# SERVICE BULLETIN

AMERICAN HONDA MOTOR CO., INC. MOTORCYCLE SERVICE DEPARTMENT

## 1979 CBX CYLINDER BASE OIL LEAKAGE

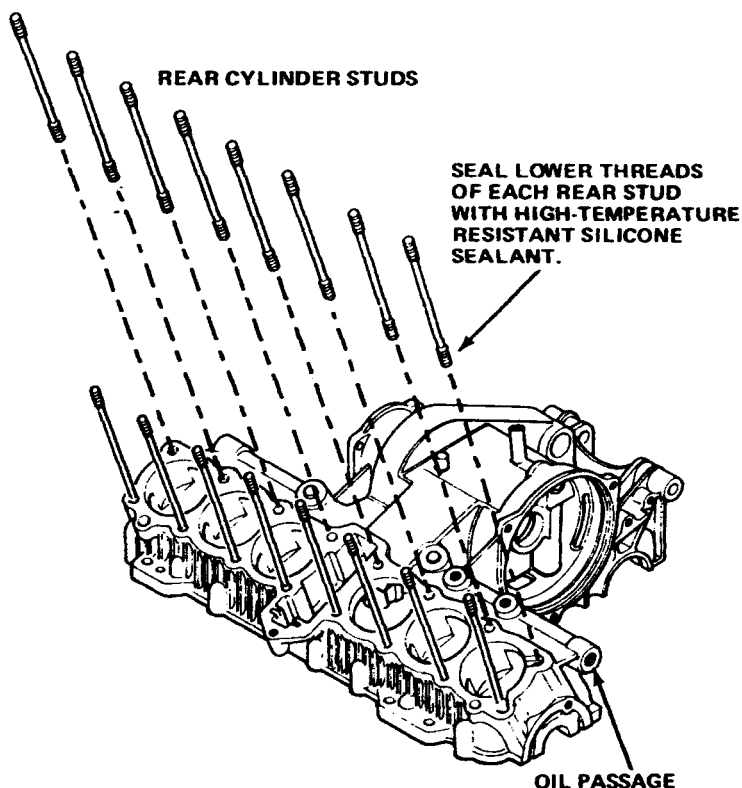
Oil leakage has occurred in some 1979 CBX engines at the base of the cylinder assembly. A major oil passage in the upper crankcase lies just behind the rear cylinder studs; engine oil from this passage may seep through the crankcase casting at the stud threads and past the cylinder base gasket.

If you encounter oil leakage from this cause, you can eliminate the problem by sealing the rear cylinder stud threads with high-temperature resistant silicone sealant.

1. Remove the cylinder assembly, and remove the rear cylinder studs. Thoroughly clean and dry the stud and crankcase threads.
2. Apply a coating of high-temperature resistant silicone sealant to the lower threads of each rear stud, and re-install.

NOTE: Use only *high-temperature resistant* silicone sealant, such as General Electric Hi-Temp Instant Gasket (stock # 56002).

3. Reassemble the engine, using new gaskets and O-rings.
